**CITY OF CALLAWAY  
GORE PARK SITE WORK  
BID NO.: LS2022-05**

**ADDENDUM #1**

Date Issued: February 22, 2022

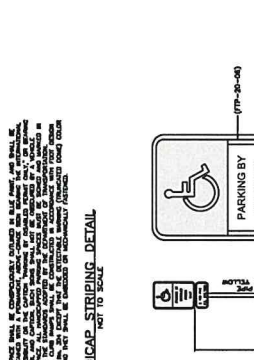
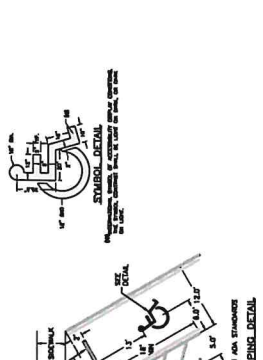
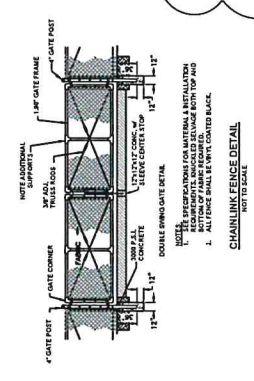
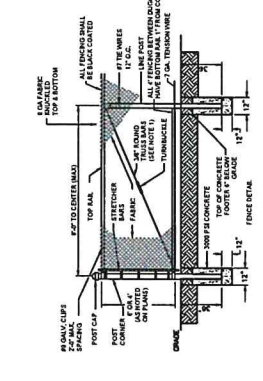
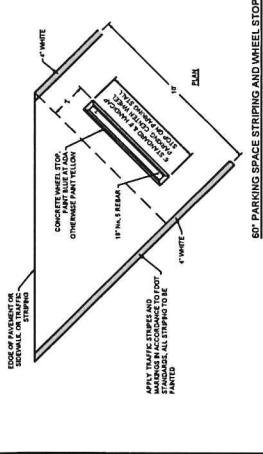
5. Is Minneola St. being demo’d by city or by the contractor?

**Minneola St. shall receive full depth reclamation by the site contractor. See attached revised sheets C1 and D1.**
